REQUEST

Current Zoning: CC (commercial center)
Proposed Zoning: CC SPA (commercial center, site plan amendment)

Approximately 31.94 acres located along the east side of Interstate 485 and west side of Dutch Creek Drive, north of Rocky River Road.

The petition proposes to amend a previously approved plan in order to accommodate additional residential units and a reduction in the amount of commercial square footage on vacant acreage abutting Cabarrus County.

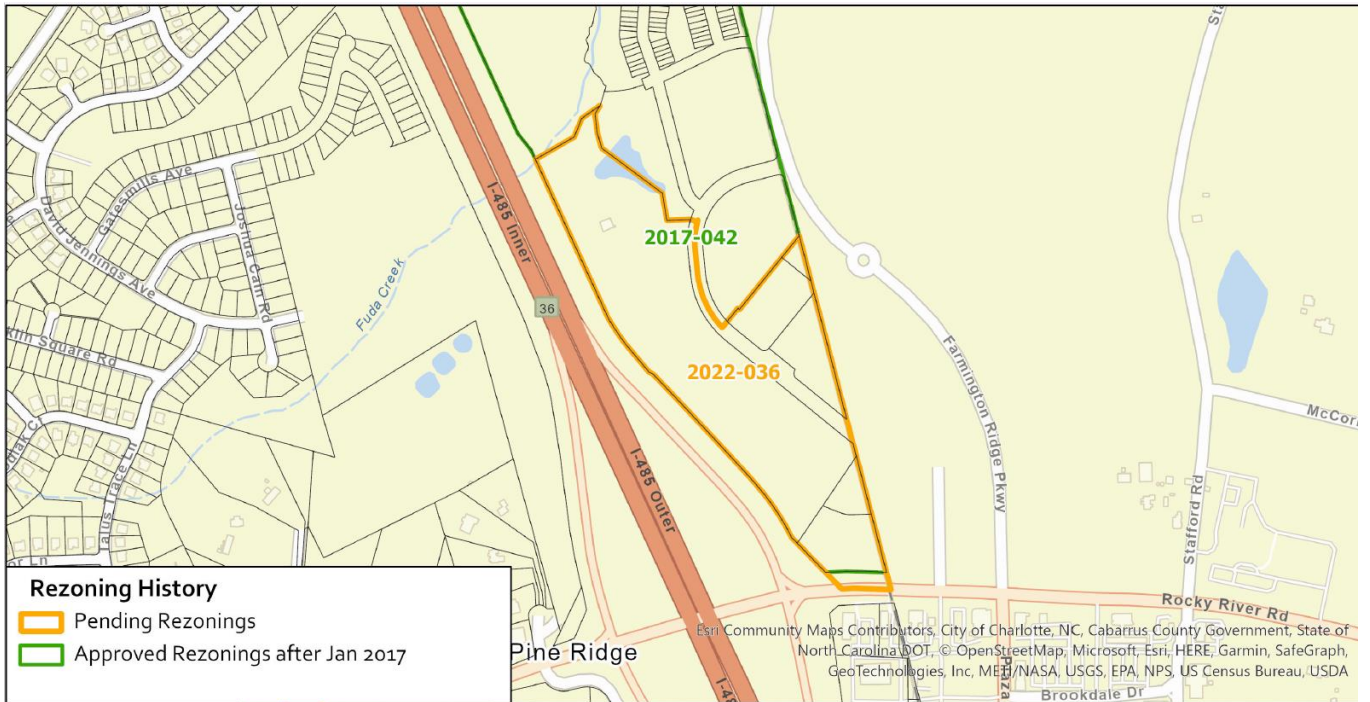
The rezoning site (denoted by purple star) is vacant and abuts I-485 to the west, acreage under construction in Cabarrus County to the east, residential uses to the north, and non-residential uses to the south.
